**REVISION 003 TO A  
INVITATION TO TENDER**

<b>Title - Sujet :</b> Lake Louise Pipestone Waterline Crossing – Banff National Park	
<b>Solicitation No. - N° de l'invitation :</b> 5P420-20-0346/A	<b>Date :</b> January 19, 2021
<b>Amendment No. - N° de modification :</b> 003	
<b>Client Reference No. - N° de référence du client :</b> 914	
<b>GETS Reference No.   N° de référence de SEAG :</b> PW-20-00938896

## AMENDMENT 003

This addendum is being issued to distribute questions and answers, make changes to the tender package, and to replace Appendix 1 - Combined Price Form.

**PRE-INSULATED WATERMAIN DETAILS**

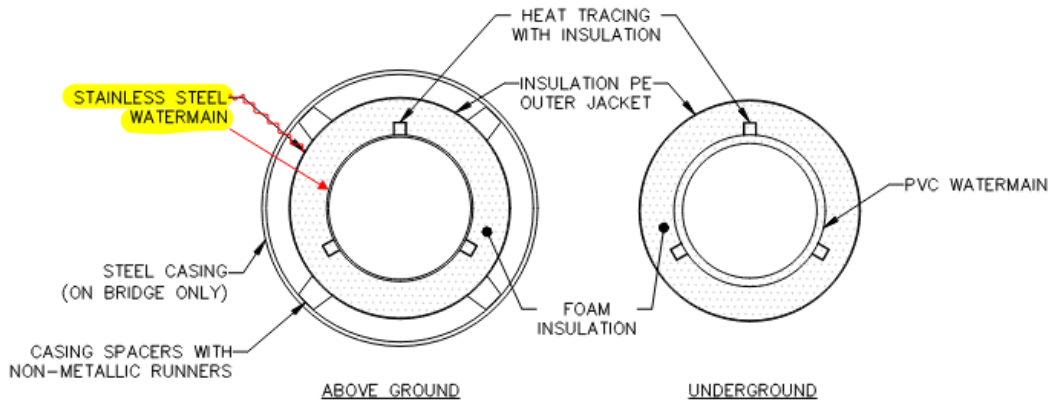
**Q8** Drawing C105, detail “Pre-insulated Watermain details”

For the above ground section, the tag “stainless steel watermain” is indicating the edge of the foam insulation instead of the inner circle.

Can you clarify this?

**A8** Leader “stainless steel watermain” should point to the inner circle. Detail to be updated in IFC drawings.
